MISSISSIPPI POWER & LIGHT COMPANY

SUBJECT: Grand Gulf Nuclear station
Units 1 and 2
Docket Nos. 50-416 and 50-417
File 0260/L-334.0
Transmittal of Proposed FSAR
Changes and Responses to
NRC Questions
Reference: NRC Question 031.67
AECM-81/341

In response to your request for additional information, Mississippi Power & Light Company is submitting the enclosed material updating information pertaining to references above.

Figure 1 Cold Reference Leg Design

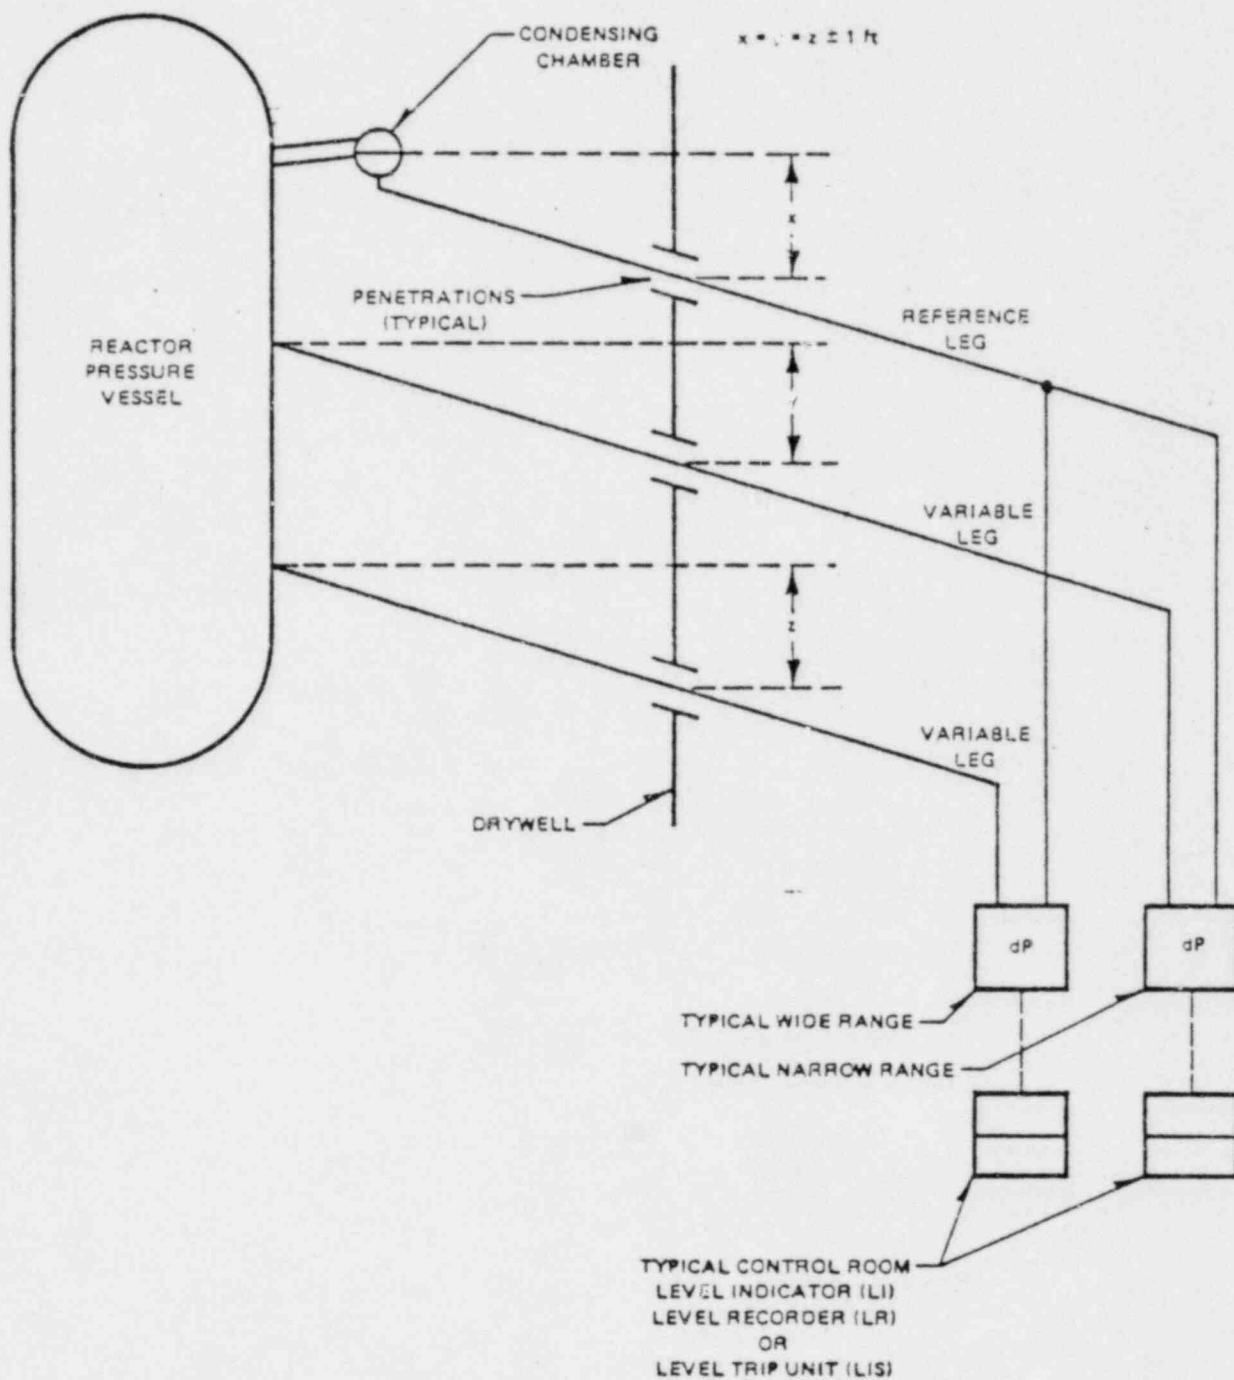
Provide additional information regarding water level instrument error expected from reference leg boil off during accident conditions.

The cold reference leg reactor water level measurement design for Grand Gulf is illustrated in Figure 1. Reactor vessel water level is measured by differential pressure transmitters which measure the difference in static head between two columns of water. One column is a "cold" (ambient temperature) reference leg outside the reactor vessel; the other is the reactor water inside the reactor vessel. The measured differential pressure is a function of reactor water level.

The cold reference leg is filled and maintained full of condensate by a condensing chamber at its top which continuously condenses reactor steam and drains excess condensate back to the reactor vessel through the upper level tap connection to the condensing chamber. The upper vessel level tap connection is located in the steam zone above the normal water level inside the vessel. Thus, the reference leg presents a constant reference static head of water to the high pressure tap on the d/p transmitter. The low-pressure tap of the transmitter is piped to a lower-level tap on the reactor vessel which is located in the water zone below the normal water level in the vessel. The low-pressure side of the transmitter thus senses the static head of water/steam inside the vessel above the lower vessel level tap. This head varies as a function of reactor water level above the tap and is the "variable leg" in the differential pressure measured by the transmitter. Lower taps for various instruments are located at various levels in the vessel water zone to accommodate both narrow- and wide-range level measurements (see Figure 2).
